TRAILS AT ASPEN RIDGE FILING NO. 5

FINAL GRADING & EROSION CONTROL PLANS

EPC STORMWATER REVIEW COMMENTS
IN ORANGE BOXES WITH BLACK TEXT

Reviewed by:
Glenn Reese, P.E.
Stormwater Engineer II
GlennReese@ElPasoCo.com
719-675-2654

TRAILS AT ASPEN RIDGE- F5					
GRADING AND EROSION CONTROL PLAN					
TITLE SHEET					
DESIGNED BY:	CRD	SCALE:	DATE ISSUED:	OCTOBER 2021	DRAWING No.
DRAWN BY:	CRD	HORIZ. N.A.	SHEET	1 OF 7	TS01
CHECKED BY:	NMS	VERT. N.A.

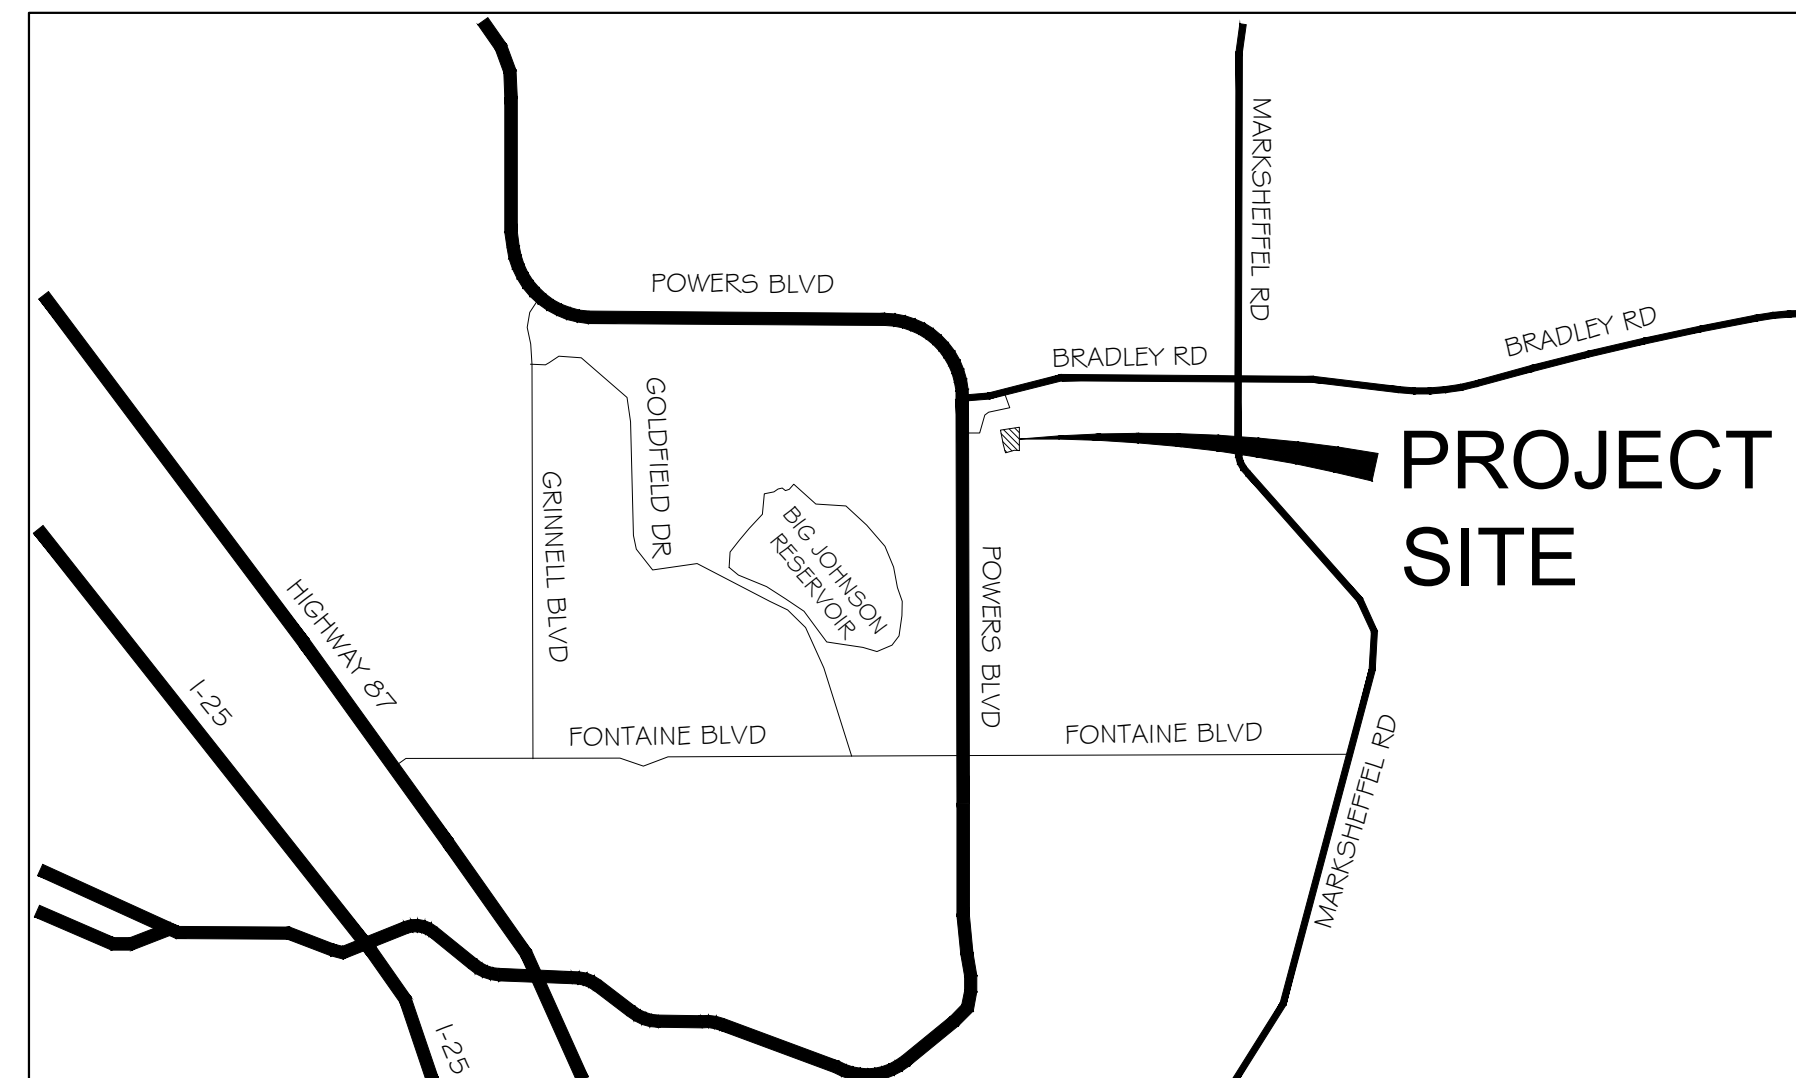
typical comment, all sheets.

Add PCD File No SF-21-038

TRAILS AT ASPEN RIDGE- F5				
GRADING AND EROSION CONTROL PLAN				
GRADING & EROSION CONTROL PLAN				
DESIGNED BY:	CRD	SCALE:	DATE ISSUED:	OCTOBER 2021
DRAWN BY:	CRD	HORIZ:	N.A.	DRAWING No. GEC01
CHECKED BY:	NMS	VERT:	N.A.	SHEET 4 OF 7

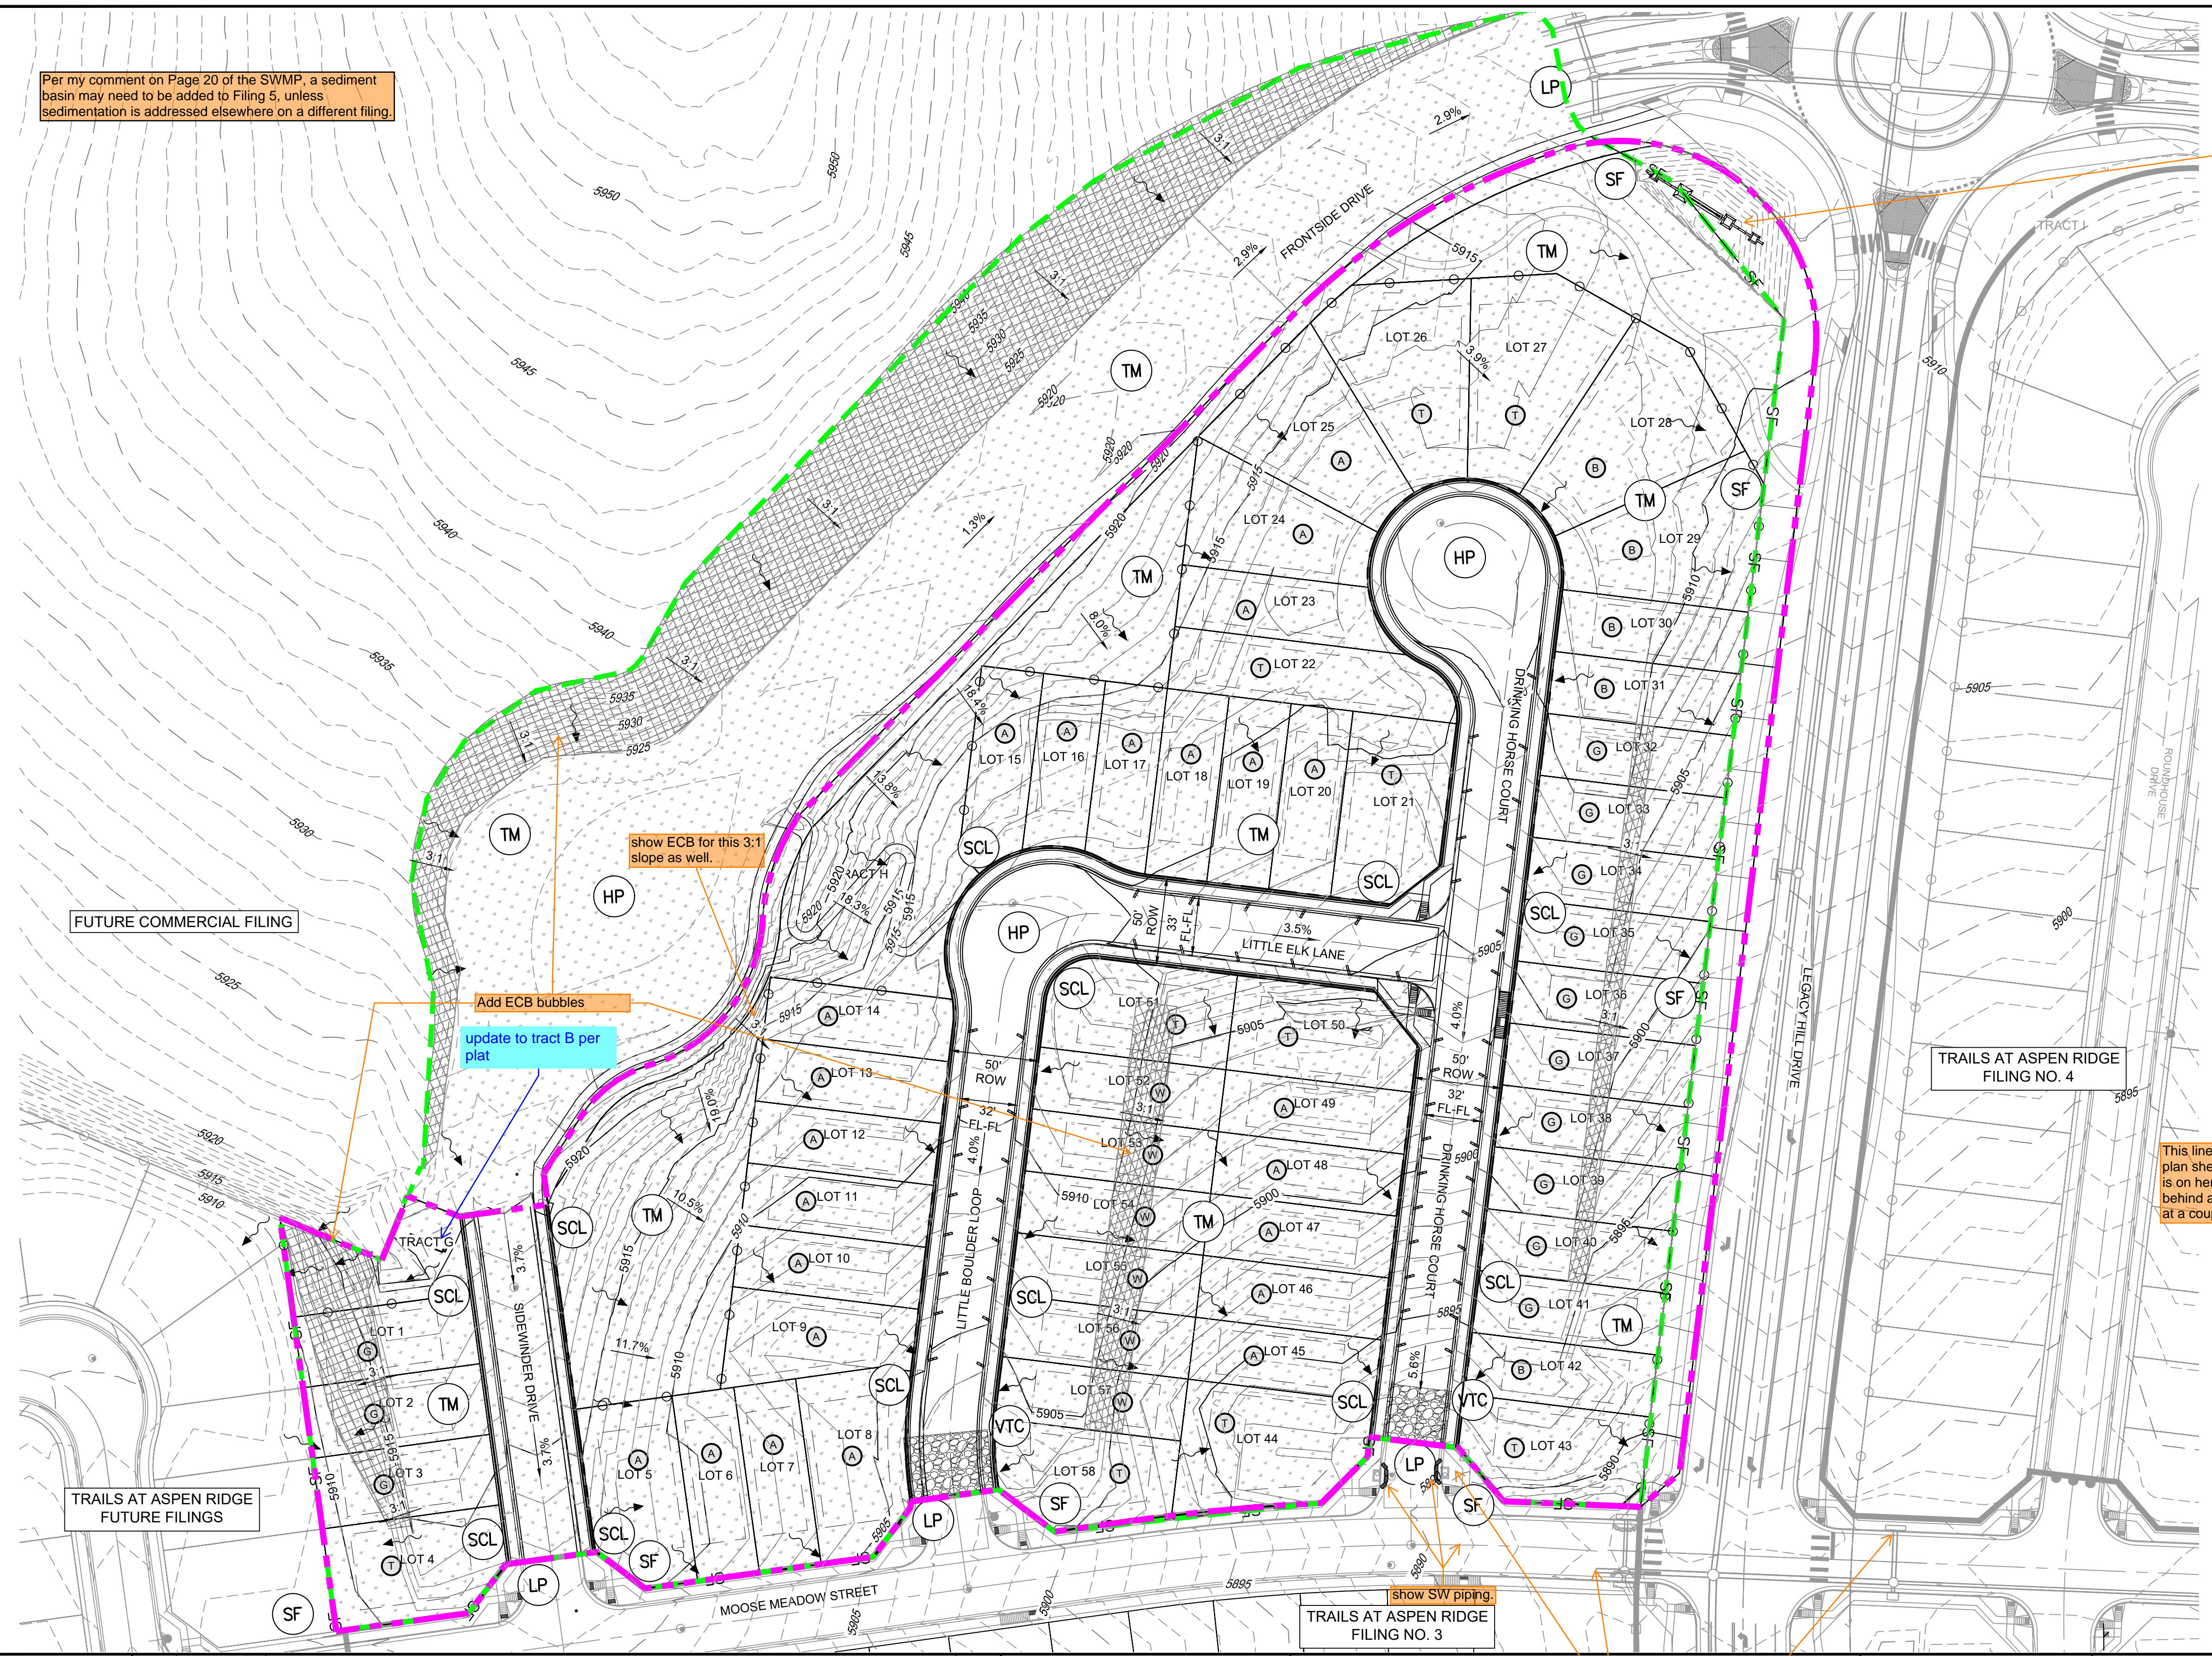
Per my comment on Page 20 of the SWMP, a sediment basin may need to be added to Filing 5, unless sedimentation is addressed elsewhere on a different filing.

show ECB for this 3:1 slope as well.

Add ECB bubbles

update to tract B per plat

This linetype is not seen on this plan sheet. Please add it in. If it is on here but is maybe hidden behind another linetype, label it at a couple of points to clarify.

show SW piping.

show "grayed-out" existing IP
